SECTION 96 SUBMISSION

DEE WHY RSL CLUB - 932 PITTWATER ROAD
STAGE 5 CLUB EXTENSION

THIS PLAN TO BE READ IN CONJUNCTION WITH
MOD2018/0119
NORTHERN BEACHES COUNCIL

PROJECT:
STAGE 5 - CLUB EXTENSION
PHASE 2 WORKS - SOUTHERN
CARPARK & ENCLOSURE

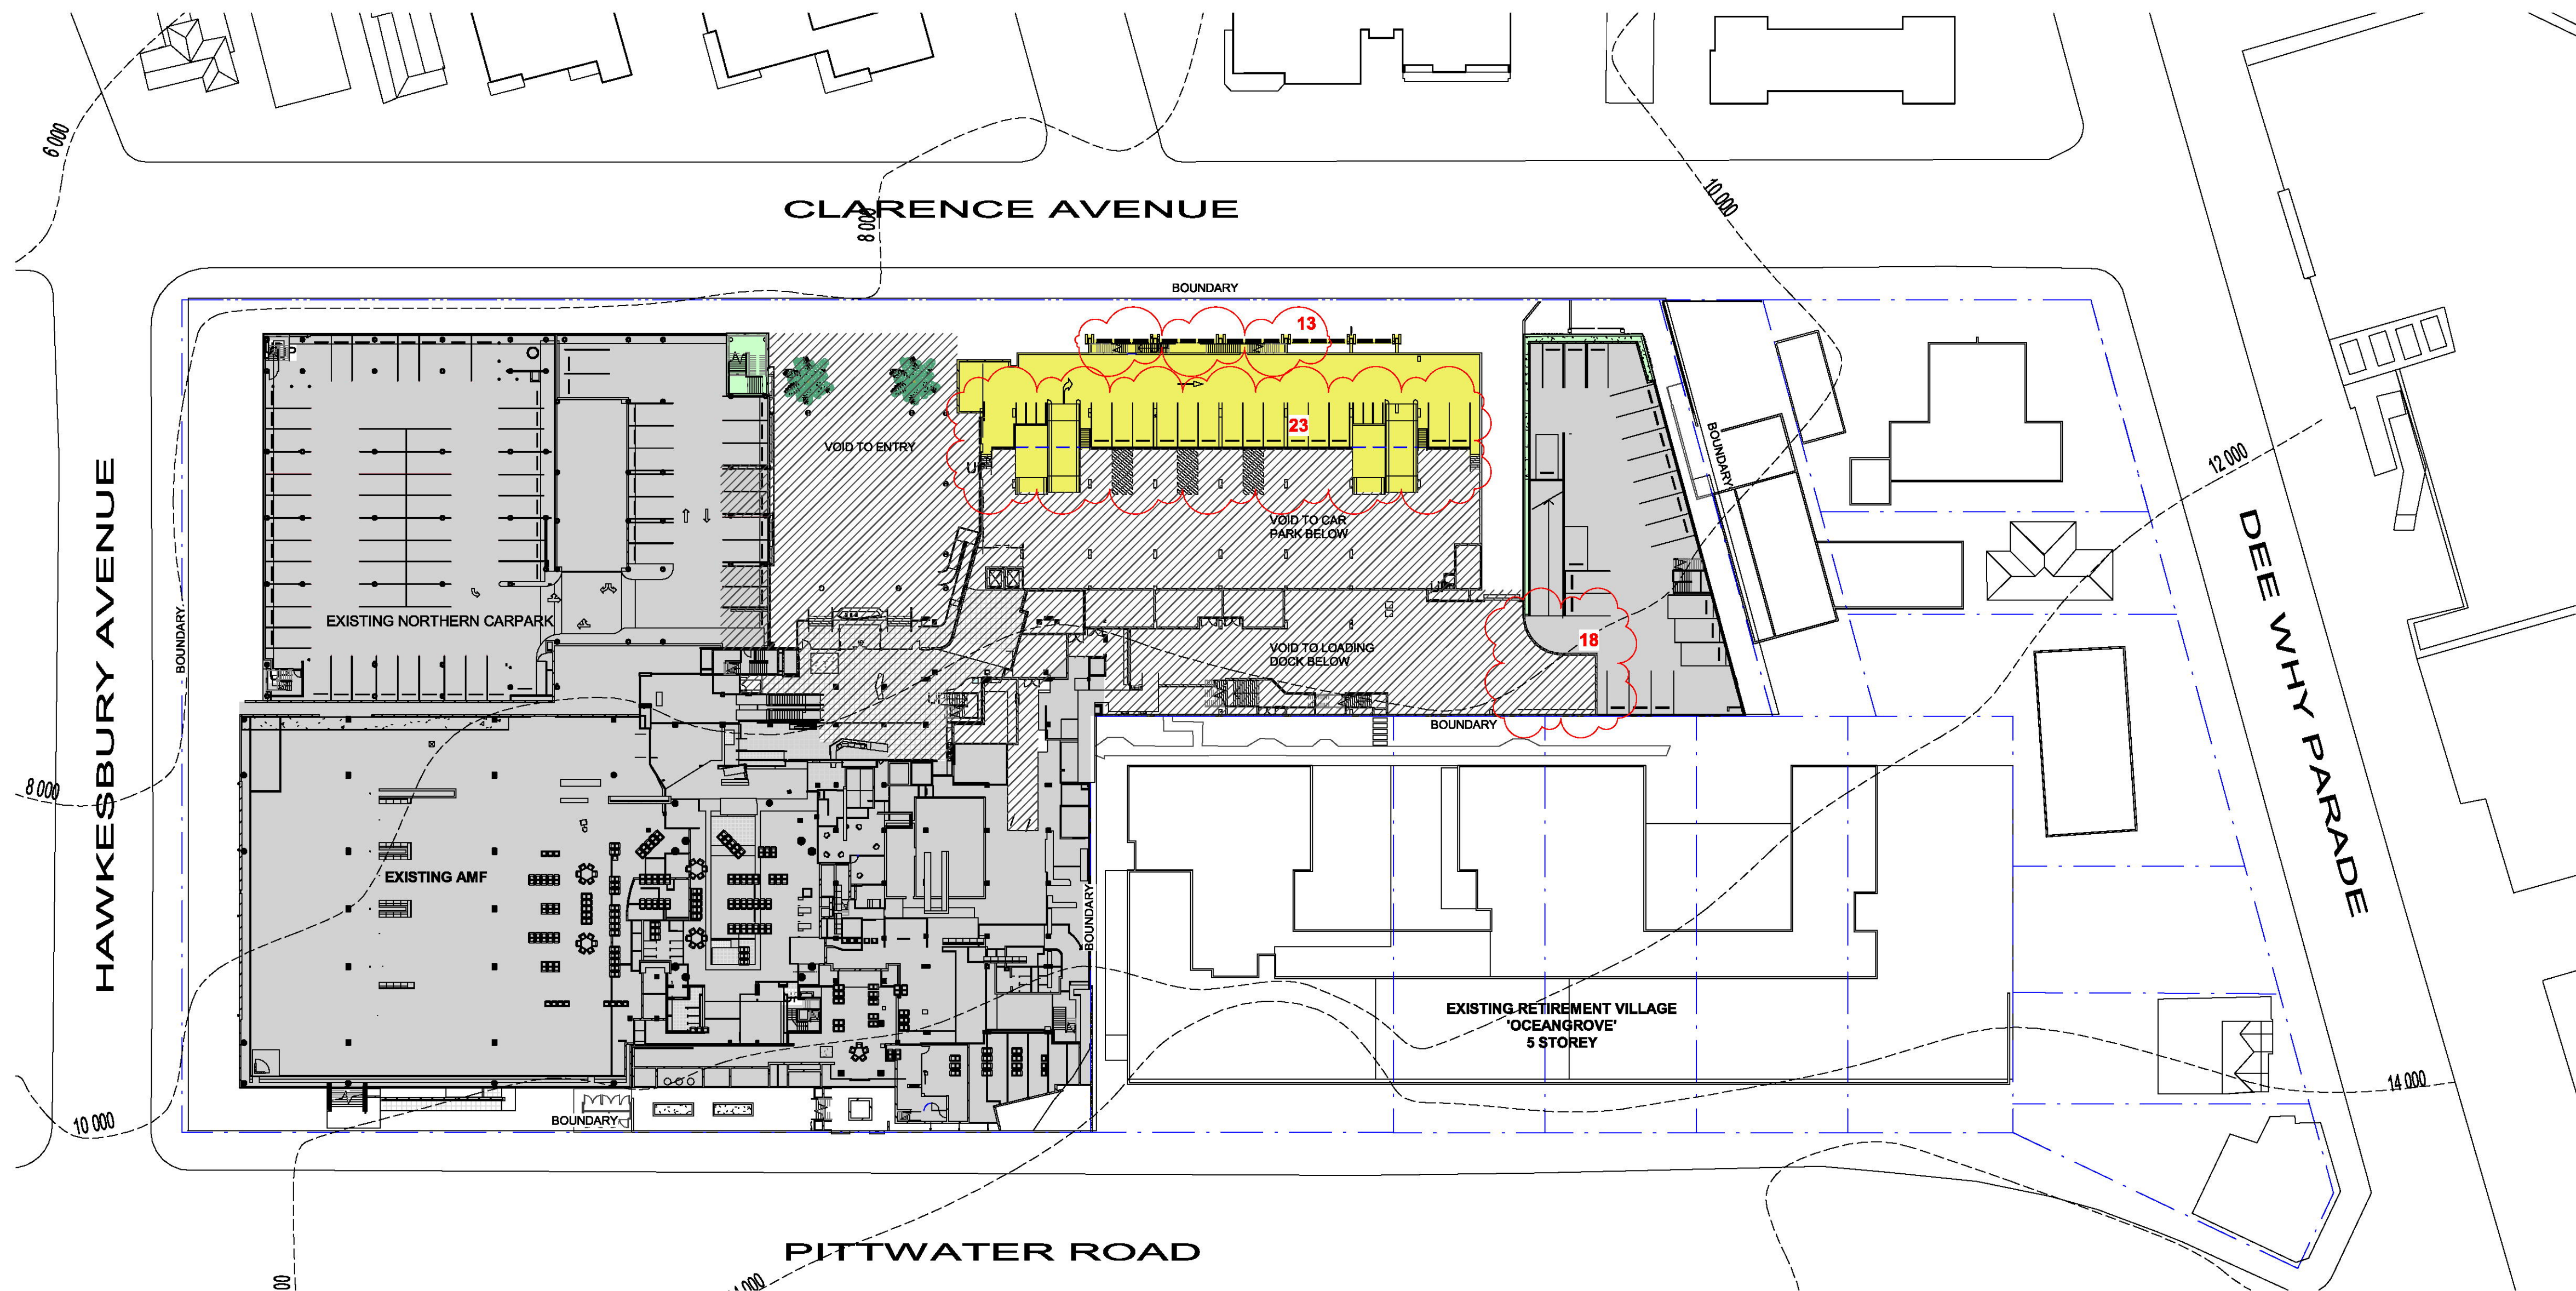
ISSUE	DATE	DESCRIPTION
1	17.03.2017	ISSUED FOR DEVELOPMENT APPLICATION
2	05.03.2018	ISSUED FOR SECTION 96
CHANGES FOR SECTION 96 APPROVAL		
roof		
1. RELOCATED OPEN PLANTROOM AT THE ROOF LEVEL

2. MODIFIED ROOF OPENING ABOVE MAIN ENTRANCE		
3. MODIFIED CENTRAL SKYLIGHT (REDUCED HEIGHT, MODIFIED PITCH)		
4. MODIFIED COURTYARD: TWO OPEN COURTYARDS AND ONE SKYLIGHT COVERED AREA INSTEAD OF ONE LARGE GLASS ROOF. REDUCED HEIGHT AND PITCH

5. MODIFIED SMOKING TERRACE: ROOF OPENING, SIZE AND PLANTED AREA. AREA REDUCED BY 21m ²		
6. REDUCED NUMBER OF ROOF SKYLIGHTS ABOVE ASIAN RESTAURANT: 2 INSTEAD OF 6 TO SUIT THE NEW INTERNAL LAYOUT

7. MODIFIED EXIT STAIR: POSITION, CONFIGURATION, METAL ROOF NO LONGER REQUIRED		
8. CONCRETE ROOF INSTEAD OF METAL DECK ROOF FOR THE MAJORITY OF THE BUILDING EXTENSION

9. NO SLAB ABOVE THE EXPOSED CAR PARK LEVEL 2 IN THE SOUTH AREA		
10. NEW ACOUSTIC METAL ROOF ABOVE REVISED LOADING DOCK		
facade		
11. MODIFIED FACADE APPEARANCE DUE TO CHANGES IN THE CAR PARK LEVELS, LOADING DOCK AND EGRESS STAIRS

12. REMOVED LOUVRES ON THE BACK FACADE (WESTERN FACADE) DUE TO MECHANICAL RISER NO LONGER REQUIRED / REVISED LOCATION FOR EGRESS DOORS		
13. 2m WIDE INTERNAL EGRESS STAIR MODIFIED INTO TWO 1m WIDE EXTERNAL STAIRS WITH DECORATIVE BALUSTRADES

14. EXTENT OF LEVEL 2 (MAIN TRADING LEVEL) REDUCED BY 8326mm FROM THE SOUTHERN BOUNDARY AND INCREASED BY 1100mm TO THE EASTERN BOUNDARY		
15. MODIFIED FACADE CURTAIN WALL MULLION BLADES

18. REVISED LOADING DOCK ENTRANCE AND LOCATION/ ENLARGED DEMOLISHED AREA IN THE EXISTING RETAINED SOUTHERN CAR PARK		
19. NEW / MODIFIED EGRESS PATHS FROM EXISTING CARPARK LEVEL -1, NEW CARPARK LEVEL 1.

20. RELOCATED ELECTRICAL SUBSTATION / LANDSCAPED AREA MOVED TO SUIT		
21. MEDIAN STRIP ADDED AT ENTRY TO PROVIDE PLACE OF REFUGE AND ENSURE WIDTH OF ENTRY/ EXIT IS LESS THAN 8M AS PER DA CONDITION 23

24. BASEMENT CAR PARK LEVEL -5 ADDED.		
25. CAR PARK ENTRY / EXIT MOVED TOWARD NORTH BY 3044mm		
26. PLANTER MODIFIED ON THE BACK (WESTERN) FACADE DUE TO REDUCTION OF THE MAIN TRADING FLOOR SLAB

27. LOCATION OF AIR INTAKE MODIFIED		
28. EXTENT OF RESTAURANT REDUCED BY 136m ²		
29. CLUB ENTRANCE ACCESSIBLE RAMPS MODIFIED		
30. ONE ADDITIONAL EXISTING CAR PARK SPACE TO BE REMOVED FROM EXISTING NORTHERN CAR PARK

31. SOLID MASONRY WALL ADDED BETWEEN EXISTING ZONE D CAR PARK AND LOADING DOCK ACCESS.		
NEW CLUB AND CAR PARK		
ALTERATIONS TO EXISTING CLUB AND CAR PARK		
NO NEW WORKS TO EXISTING CLUB		
CLUB:		
DEE WHY RSL CLUB		
PROJECT:		
STAGE 5 - CLUB EXTENSION		
PHASE 2 WORKS - SOUTHERN CARPARK & ENCLOSURE		
ARCHITECT:		
ALTIS architecture p 61 2 9364 9000 f 61 2 9571 7930 lower deck jones bay wharf suite 123 / 26 - 32 pirrama road pyrmont nsw 2009 australia

DRAWING TITLE:
KEY PLAN - LEVEL 2

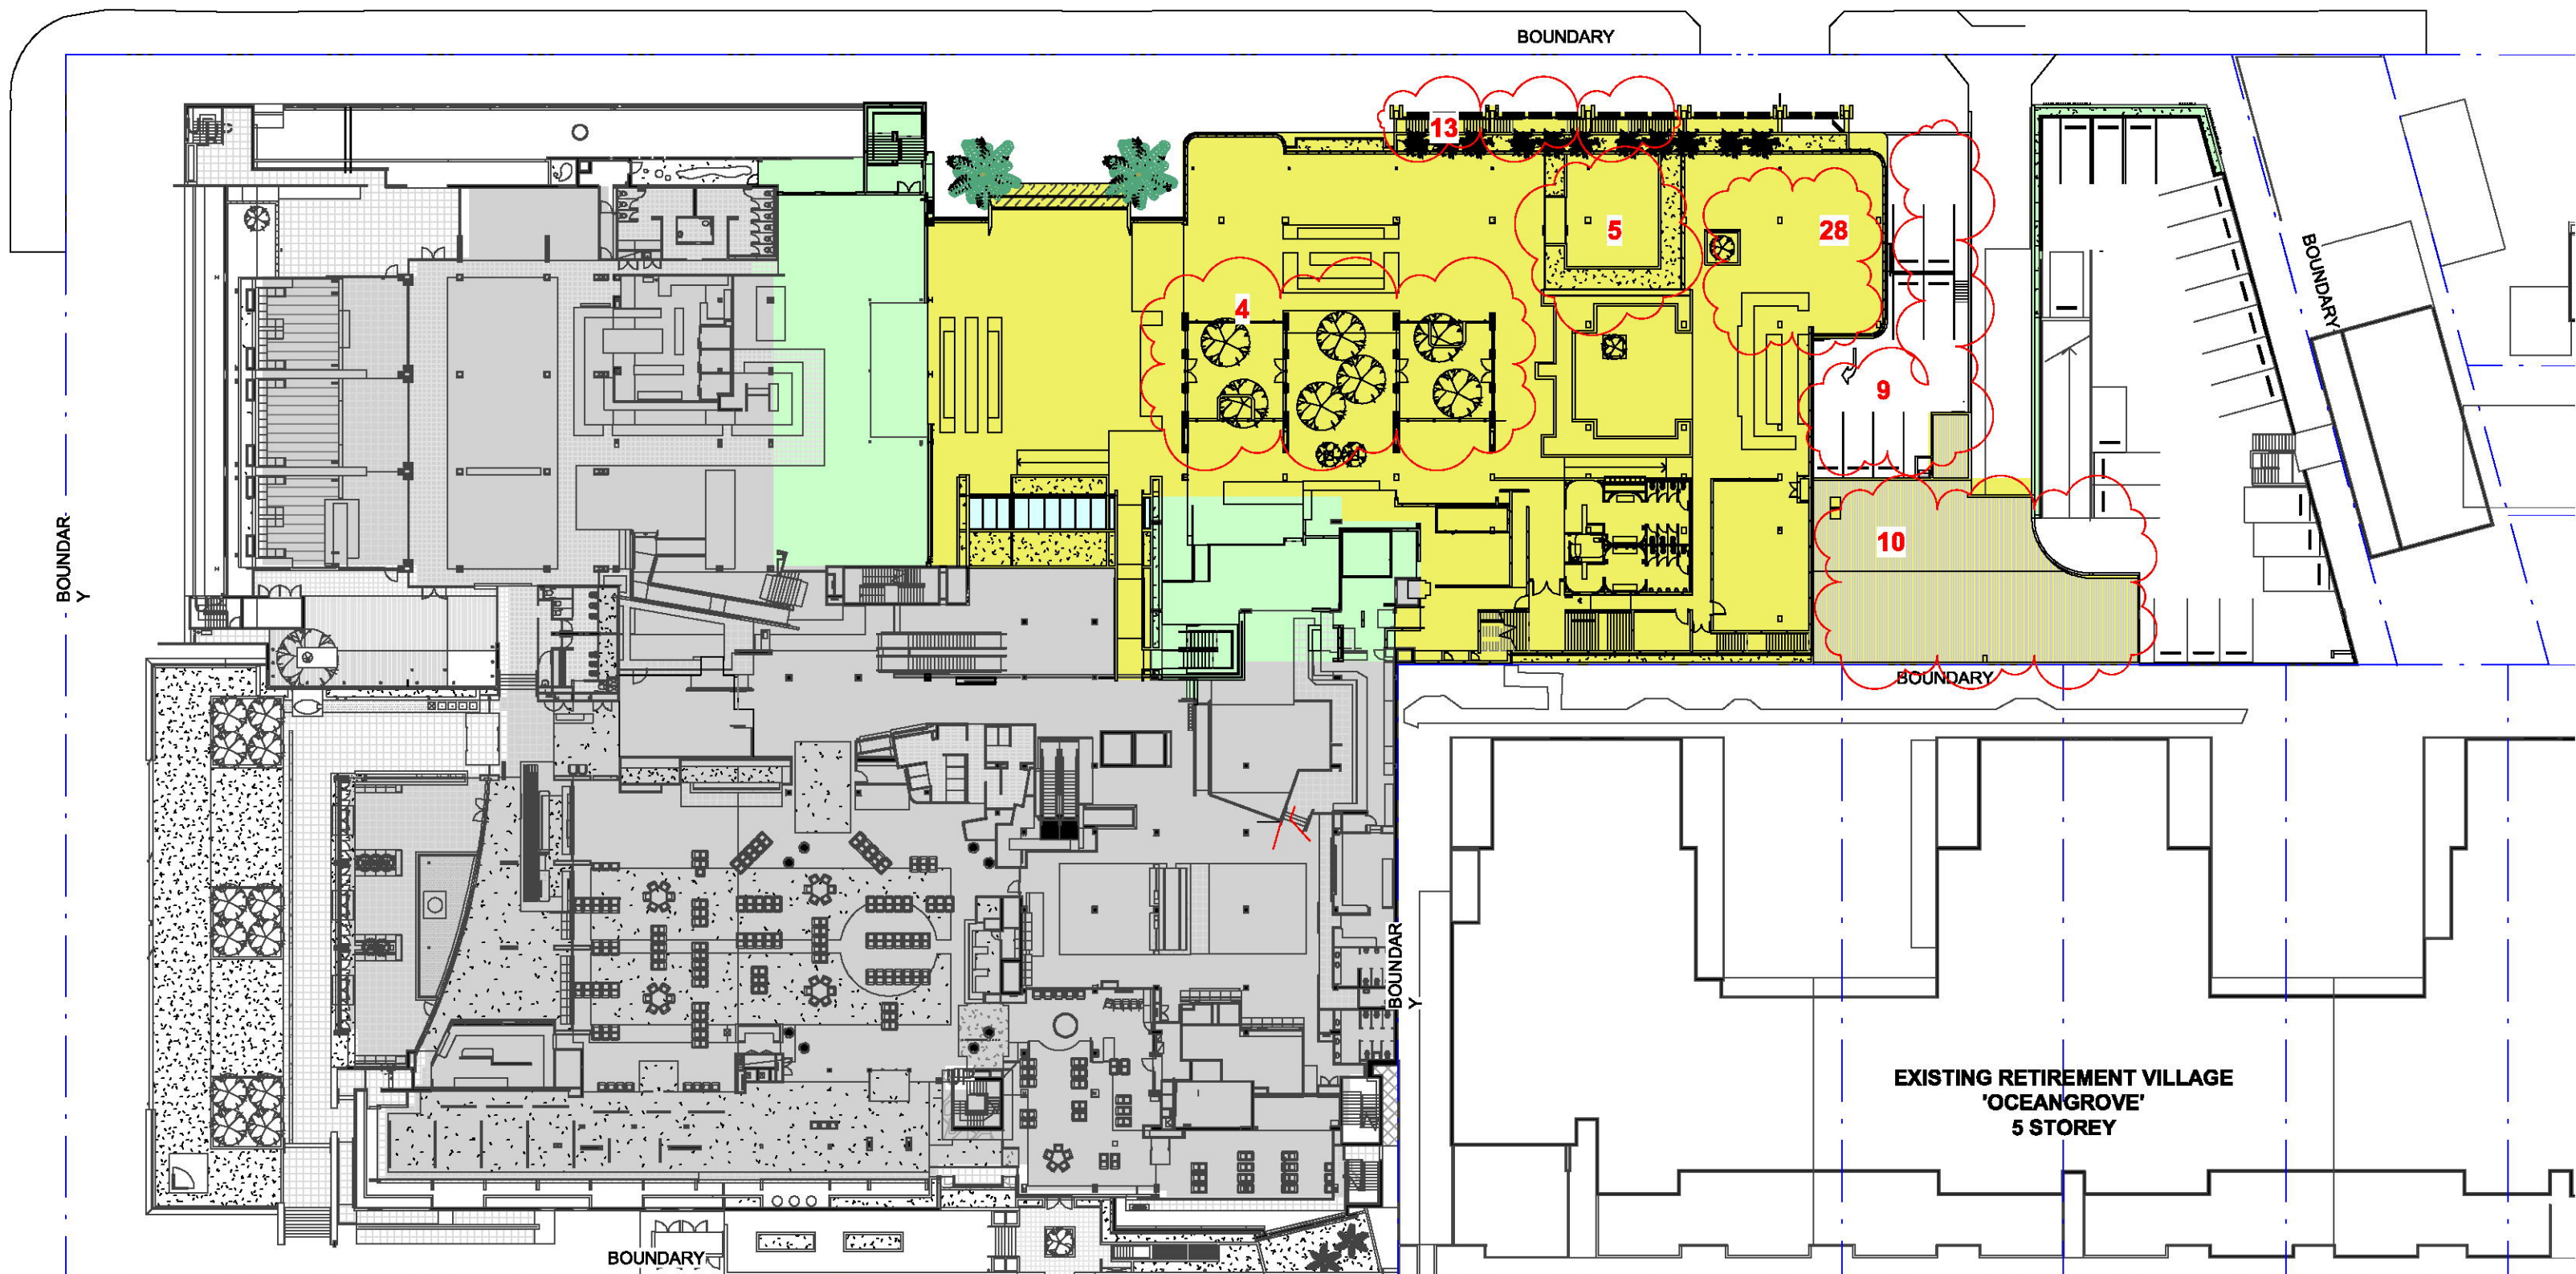
1. RELOCATED OPEN PLANTROOM AT THE ROOF LEVEL
2. MODIFIED ROOF OPENING ABOVE MAIN ENTRANCE
3. MODIFIED CENTRAL SKYLIGHT (REDUCED HEIGHT, MODIFIED PITCH)
4. MODIFIED COURTYARD: TWO OPEN COURTYARDS AND ONE SKYLIGHT COVERED AREA INSTEAD OF ONE LARGE GLASS ROOF, REDUCED HEIGHT AND PITCH
5. MODIFIED SMOKING TERRACE: ROOF OPENING, SIZE AND PLANTED AREA, AREA REDUCED BY 21m²
6. REDUCED NUMBER OF ROOF SKYLIGHTS ABOVE ASIAN RESTAURANT: 2 INSTEAD OF 6 TO SUIT THE NEW INTERNAL LAYOUT
7. MODIFIED EXIT STAIR: POSITION, CONFIGURATION, METAL ROOF NO LONGER REQUIRED
8. CONCRETE ROOF INSTEAD OF METAL DECK ROOF FOR THE MAJORITY OF THE BUILDING EXTENSION
9. NO SLAB ABOVE THE EXPOSED CAR PARK LEVEL 2 IN THE SOUTH AREA
10. NEW ACOUSTIC METAL ROOF ABOVE REVISED LOADING DOCK

11. MODIFIED FACADE APPEARANCE DUE TO CHANGES IN THE CAR PARK LEVELS, LOADING DOCK AND EGRESS STAIRS
12. REMOVED LOUVRES ON THE BACK FACADE (WESTERN FACADE) DUE TO MECHANICAL RISER NO LONGER REQUIRED / REVISED LOCATION FOR EGRESS DOORS
13. 2m WIDE INTERNAL EGRESS STAIR MODIFIED INTO TWO 1m WIDE EXTERNAL STAIRS WITH DECORATIVE BALUSTRADES
14. EXTENT OF LEVEL 2 (MAIN TRADING LEVEL) REDUCED BY 8328mm FROM THE SOUTHERN BOUNDARY AND INCREASED BY 1100mm TO THE EASTERN BOUNDARY
15. MODIFIED FACADE CURTAIN WALL MULLION BLADES
16. CONCRETE BLADE WALL REDUCED BY 1.47m IN HEIGHT AND 6.2m IN LENGTH
17. VERTICAL FINS REMOVED FROM BACK WALL (WESTERN FACADE)

18. REVISED LOADING DOCK ENTRANCE AND LOCATION/ ENLARGED DEMOLISHED AREA IN THE EXISTING RETAINED SOUTHERN CAR PARK
19. NEW / MODIFIED EGRESS PATHS FROM EXISTING CARPARK LEVEL -1, NEW CARPARK LEVEL 1.

20. RELOCATED ELECTRICAL SUBSTATION / LANDSCAPED AREA MOVED TO SUIT
21. MEDIAN STRIP ADDED AT ENTRY TO PROVIDE PLACE OF REFUGE AND ENSURE WIDTH OF ENTRY/ EXIT IS LESS THAN 8M AS PER DA CONDITION

24. BASEMENT CAR PARK LEVEL -5 ADDED.
25. CAR PARK ENTRY / EXIT MOVED TOWARD NORTH BY 3044mm
26. PLANTER MODIFIED ON THE BACK (WESTERN) FACADE DUE TO REDUCTION OF THE MAIN TRADING FLOOR SLAB

27. LOCATION OF AIR INTAKE MODIFIED
28. EXTENT OF RESTAURANT REDUCED BY 135m²
29. CLUB ENTRANCE ACCESSIBLE RAMPS MODIFIED
30. ONE ADDITIONAL EXISTING CAR PARK SPACE TO BE REMOVED FROM EXISTING NORTHERN CAR PARK

31. SOLID MASONRY WALL ADDED BETWEEN EXISTING ZONE D CAR PARK AND LOADING DOCK ACCESS.
